January 10, 2025

SBM-23-2071

**Re: Response Letter for SPA Submission Comments  
Proposed Warehouse  
33 Park Road, Simcoe, ON**

SHEET No.  
**SP1**

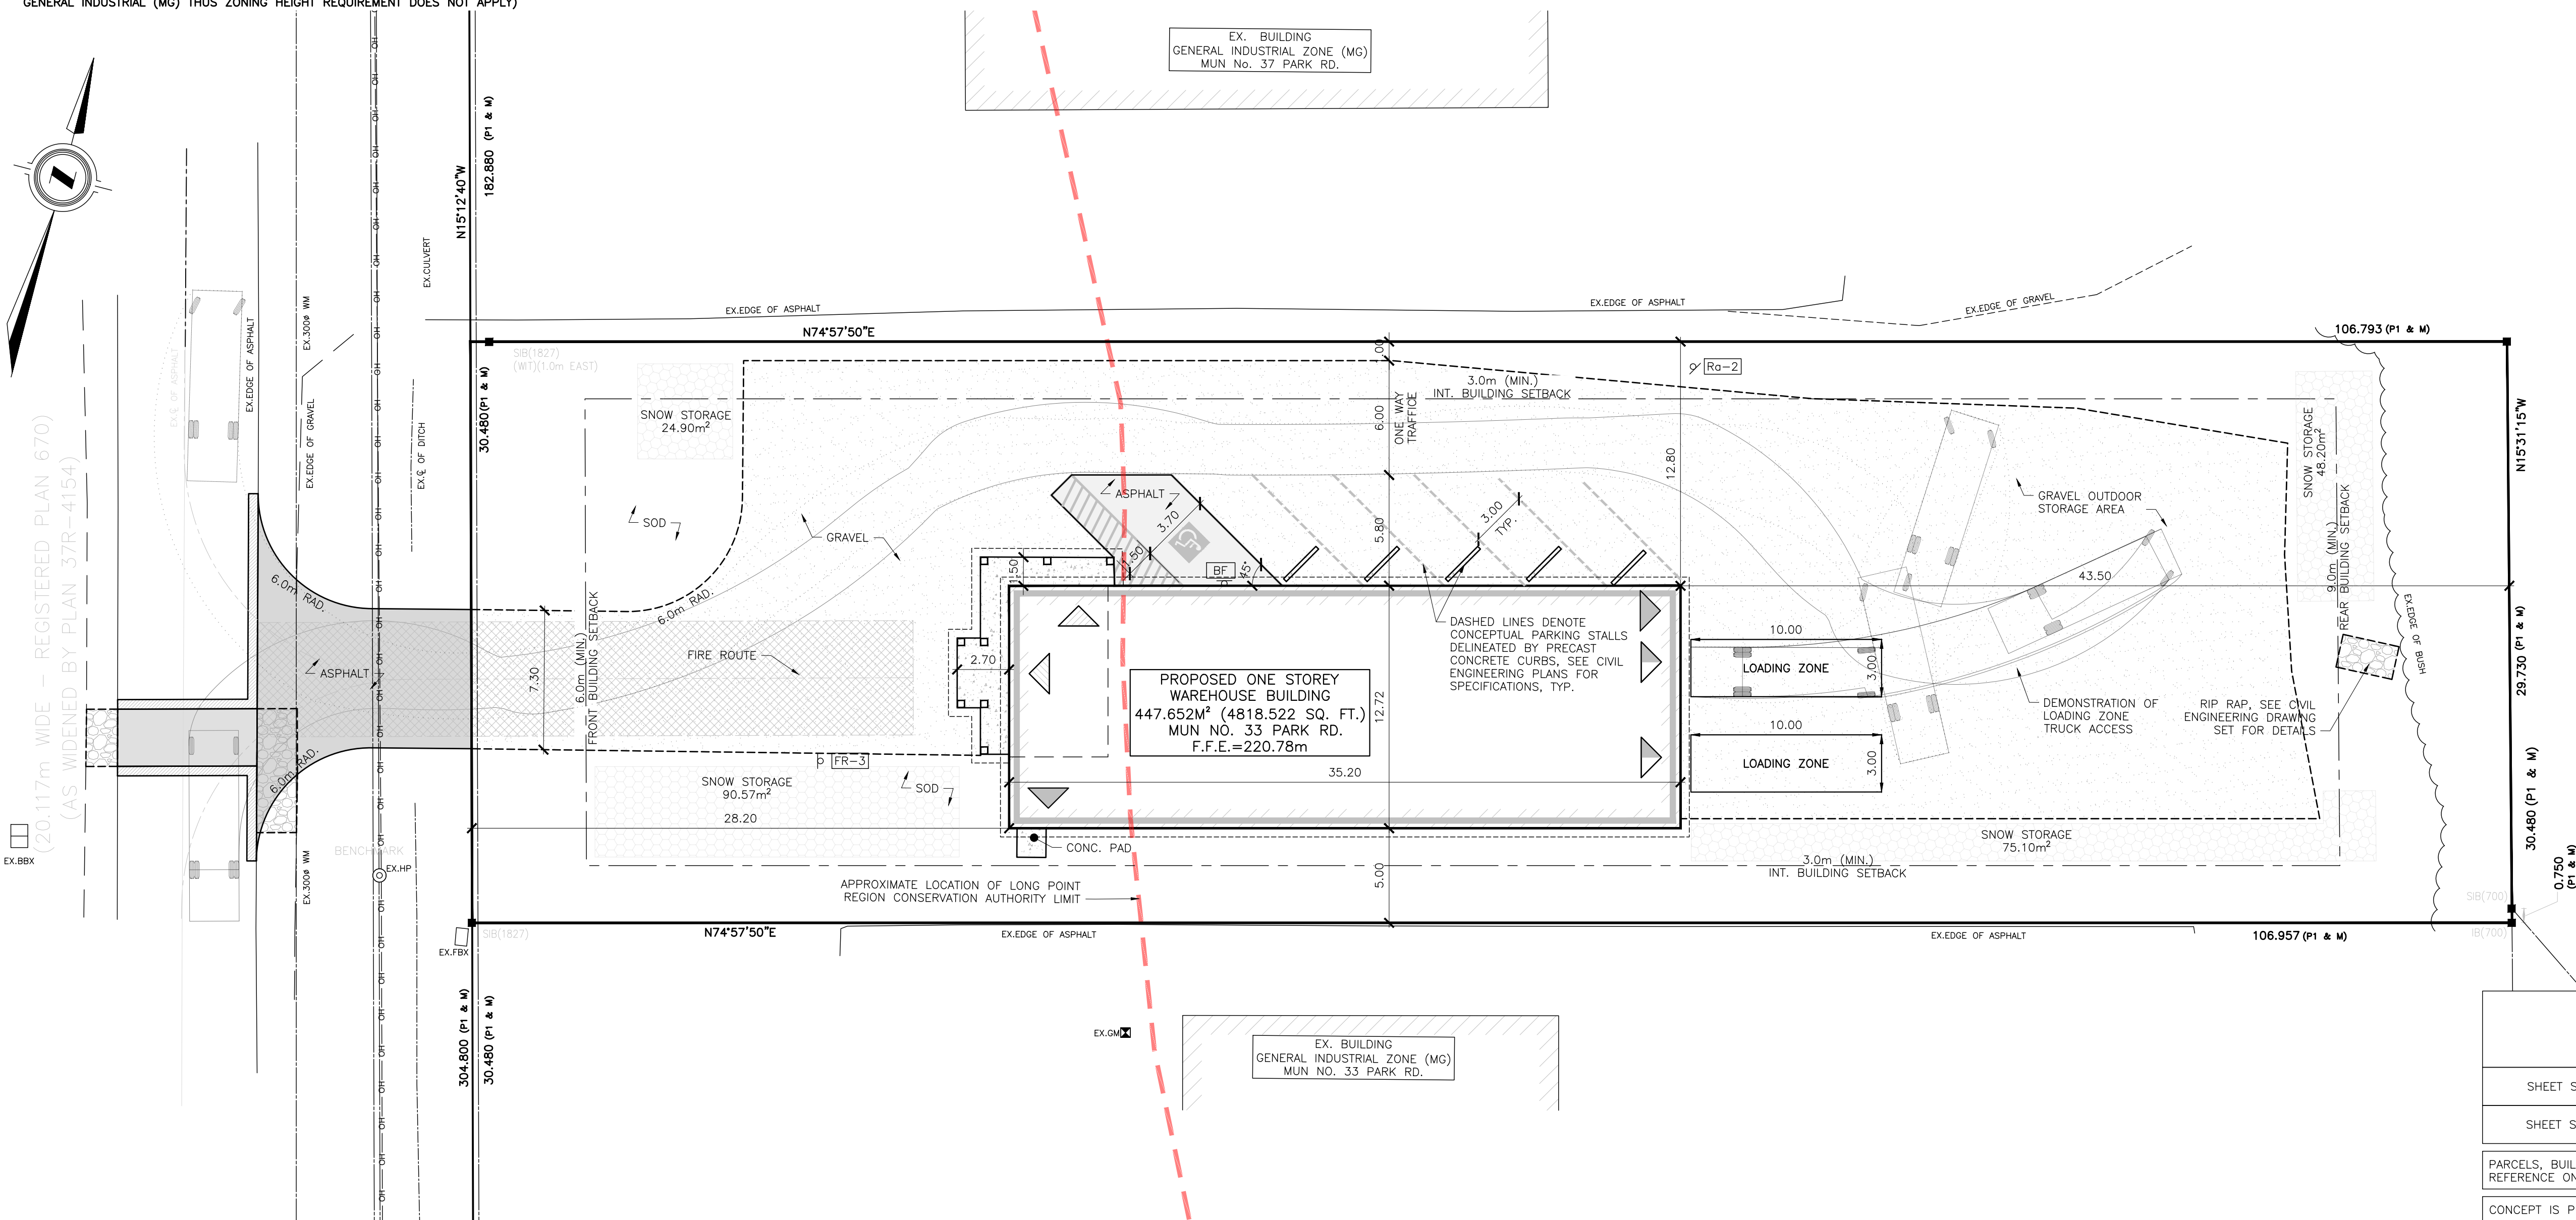
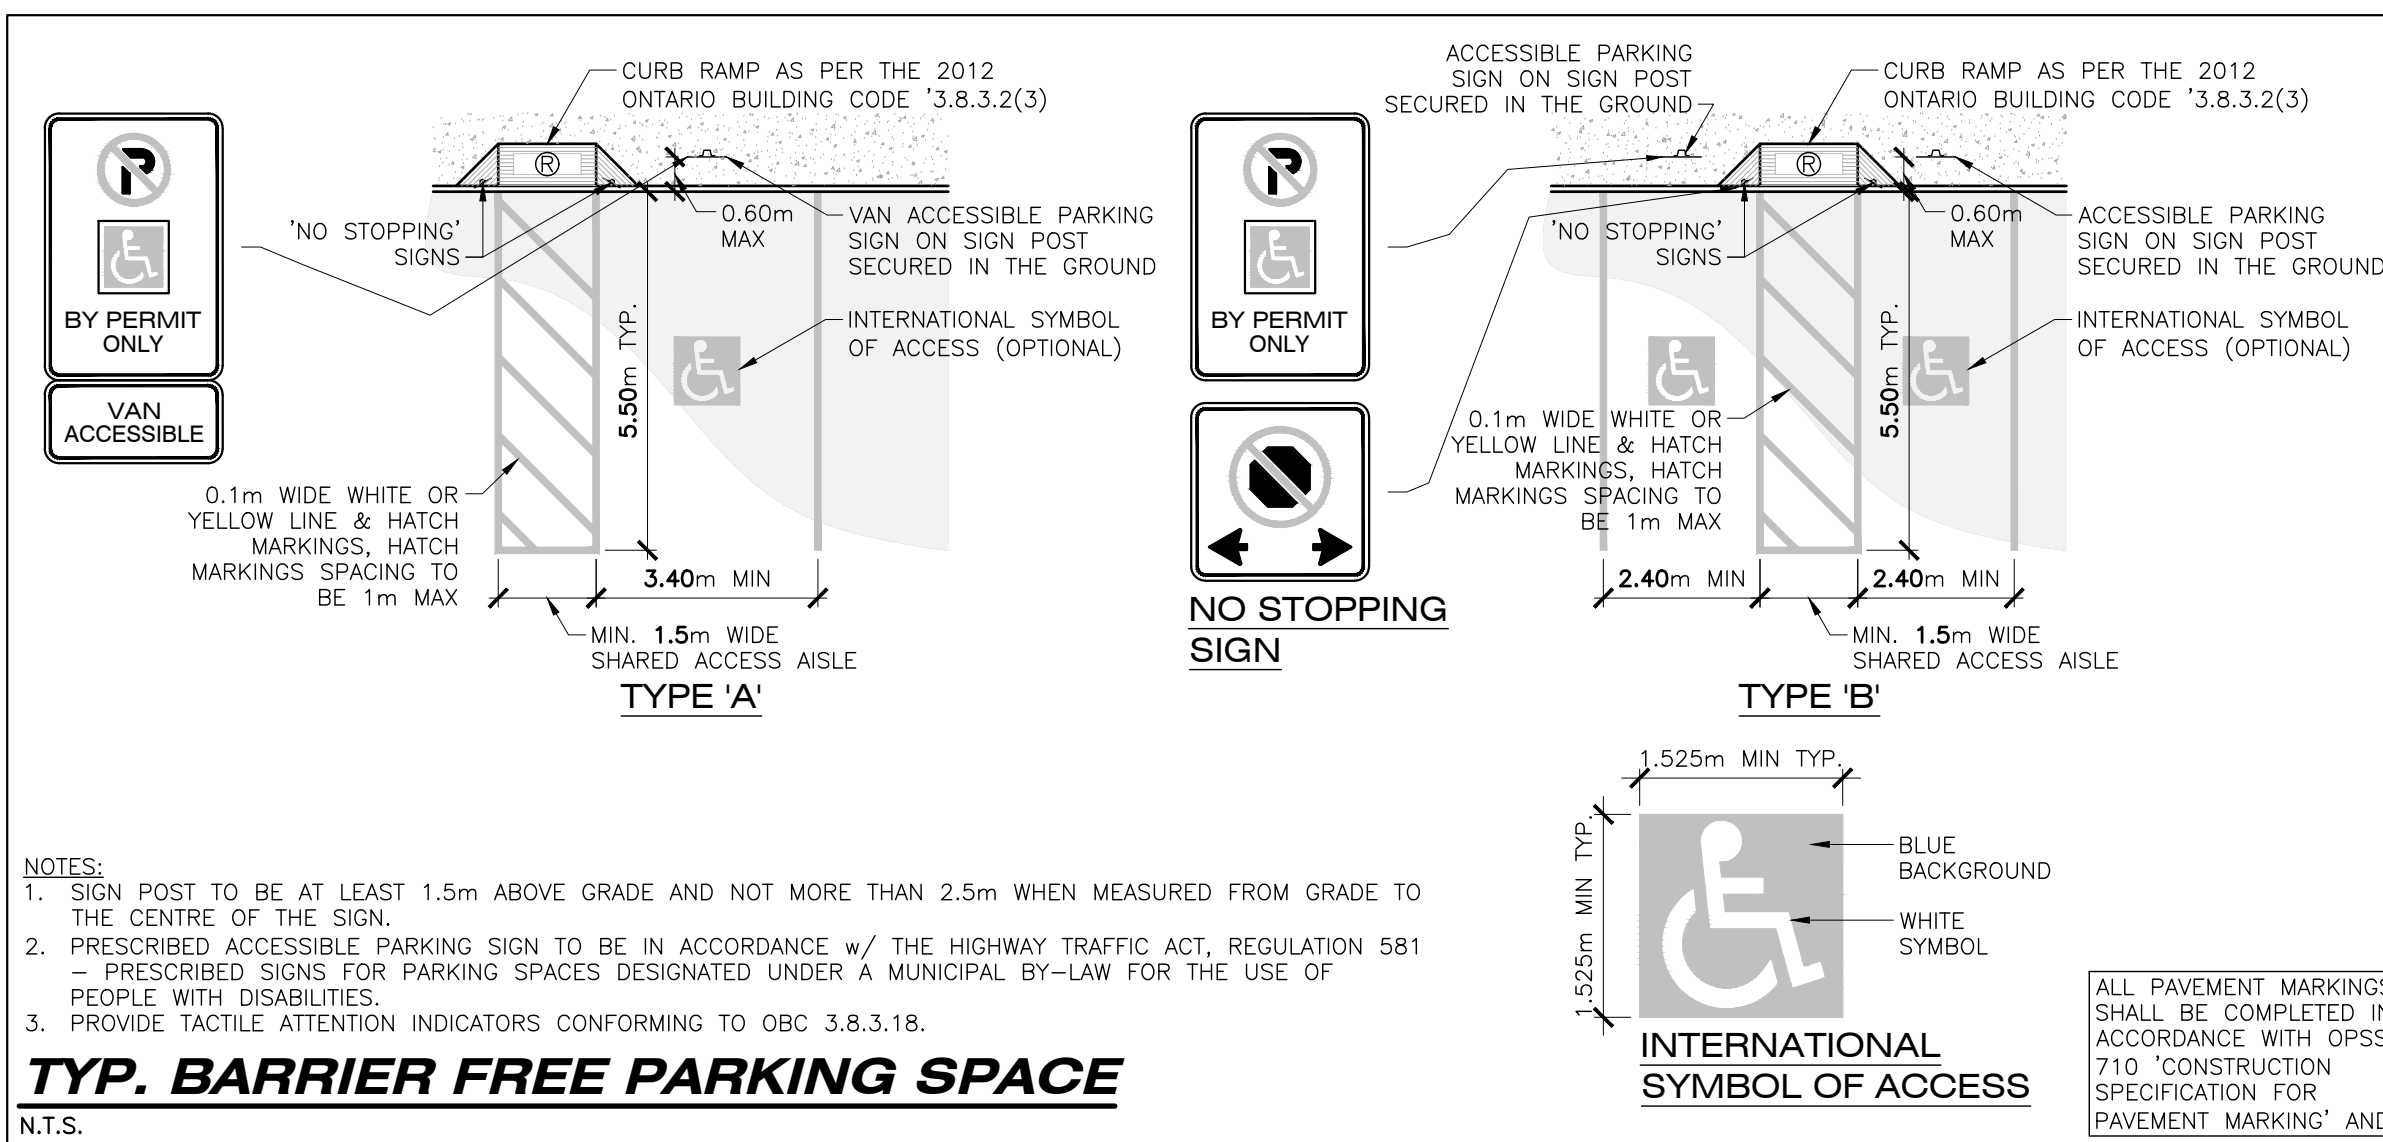
2. The proposed parking and loading areas are deficient in the following provisions of the Zoning By-law:
  - a) Loading spaces are required to be 3 metres wide by 10 metres long with room to maneuver outside of the parking area (Section 4.7), where no measurements have been demonstrated on the site plan;
  - b) The total number of standard parking spaces required is 5 (Section 4.9), where only 4 are demonstrated on the site plan;
  - c) For two-way travel a parking aisle of 7.3 metres is required (Section 4.1.4(b)), where only 6 metres to the edge of the gravel area is demonstrated on the site plan;

d) For accessible parking spaces, an access aisle of 1.5 metres in width the full length of the parking space is required (Section 43.2(a)), where this is not demonstrated on the site plan.

14. The site plan lacks sufficient lane width for safe delivery truck maneuvering at the rear of the property. Furthermore, angled parking results in limited turning radii forcing customers/employees to reverse into a negative turn near a highly sloped area (31.0%) creating safety hazards. It is recommended to revise the design to provide adequate lane widths, turning radii, and/or reconfigure parking to ensure safe truck access and maneuverability on the parking area.

*Response by SBM: Acknowledged. Please refer to the updated Site Plan by SBM, provided separately. Specifically, regarding item c); the proposed drive aisle North of the parking will facilitate traffic one-way driving eastward as they enter the site. Then exiting vehicles will be required to turn around in the rear gravel lot, yield to any oncoming eastward traffic while exiting the site travelling westward. A yield sign (Ra-2) has been added to the site for vehicles exiting.*

*Response by SBM: Adequate truck maneuverability has been demonstrated by completing a truck turning analysis as shown on the Site Plan. The analysis was performed using a 10m long, single unit two axle truck. The proposed drive aisle North of the parking will facilitate traffic one-way driving eastward as*

they enter the site. Then exiting vehicles will be required to turn around in the rear gravel lot, yield to any oncoming eastward traffic while exiting the site travelling westward. A yield sign (Ra-2) has been added to the site for exiting vehicles.

TITLE  
**SITE GRADING PLAN**  
**PROPOSED WAREHOUSE**  
33 PARK ROAD  
SIMCOE, ON.

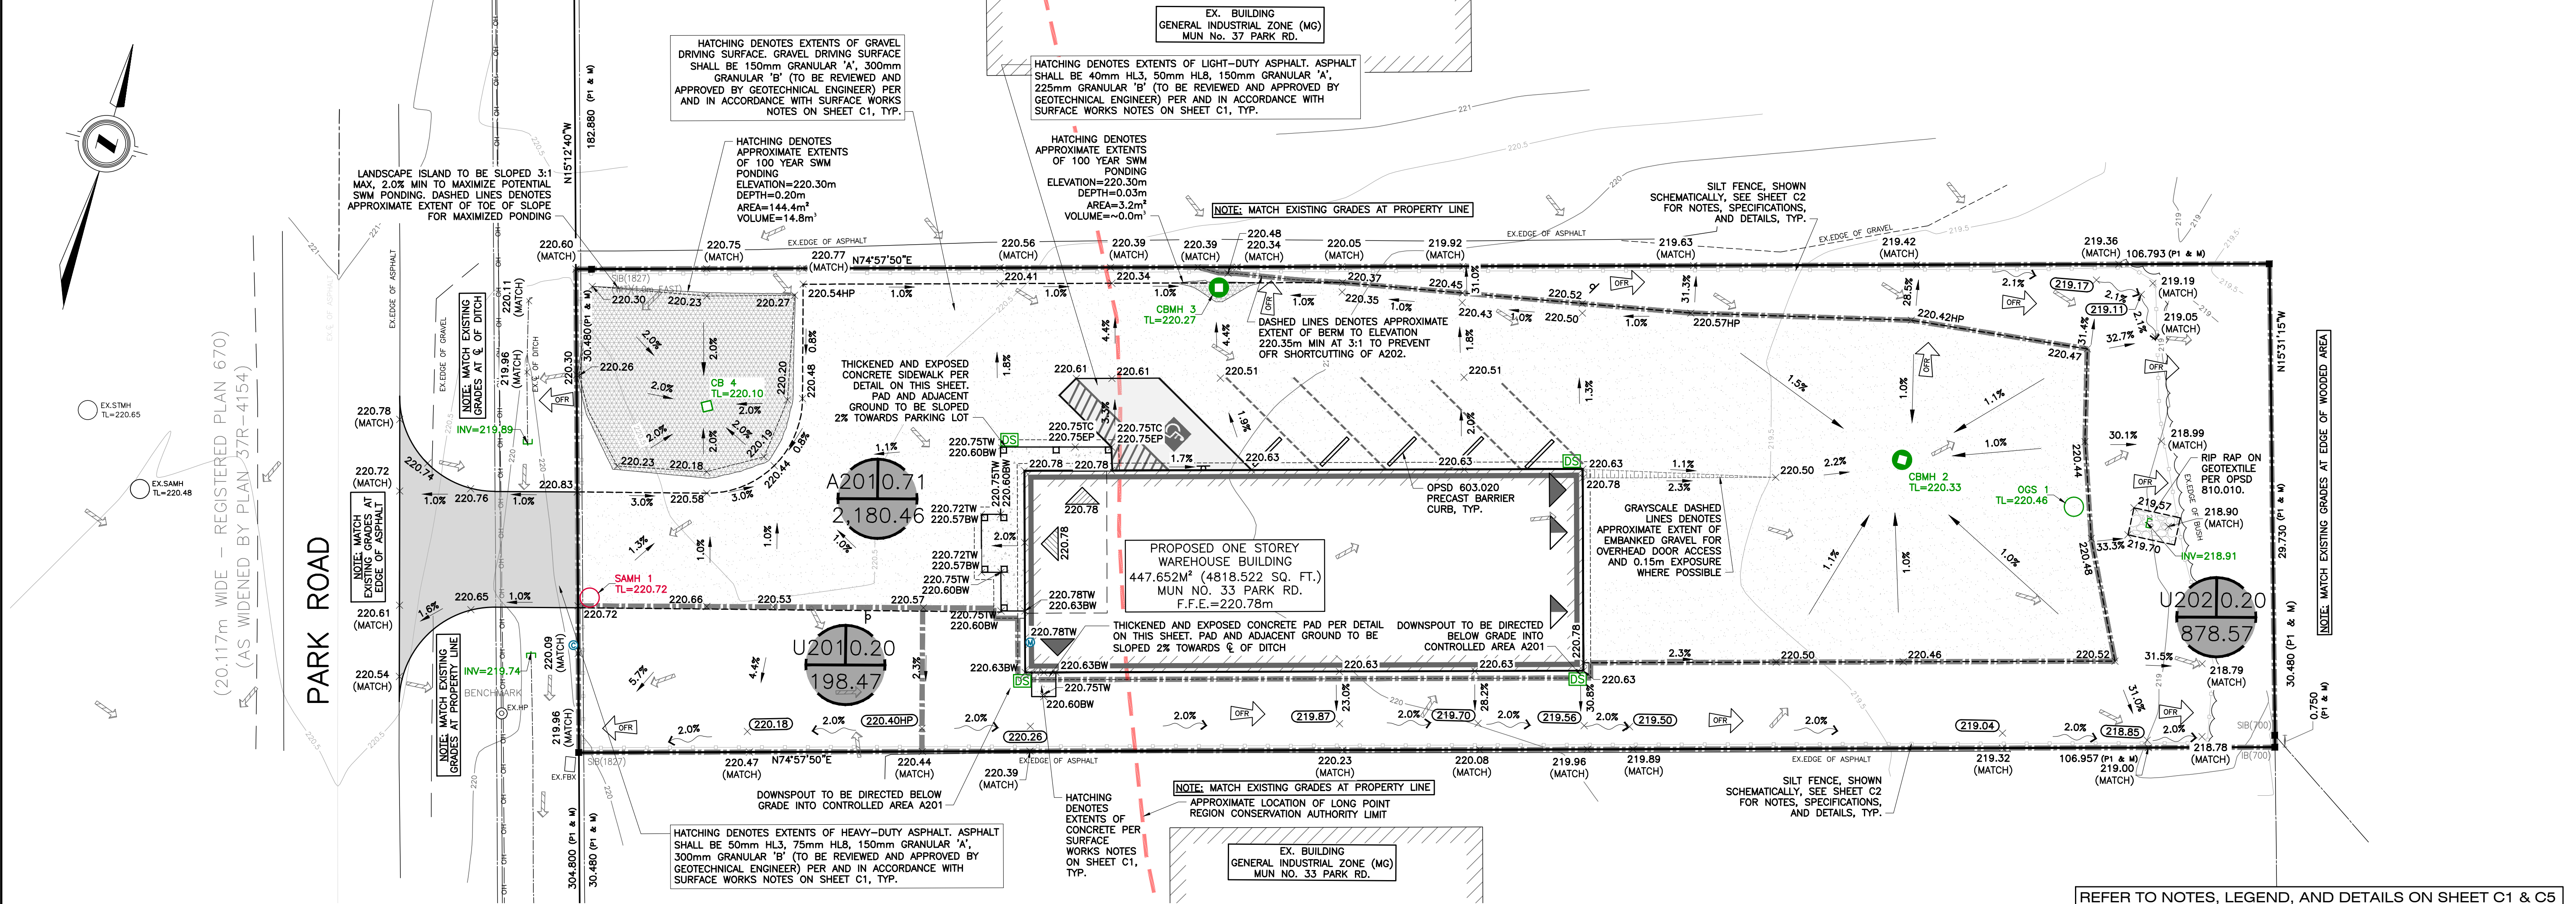
11. Please provide additional overland flow arrows in uncontrolled areas.

*Response by SBM: Acknowledged. Please refer to the updated Engineering Drawings by SBM, provided separately.*
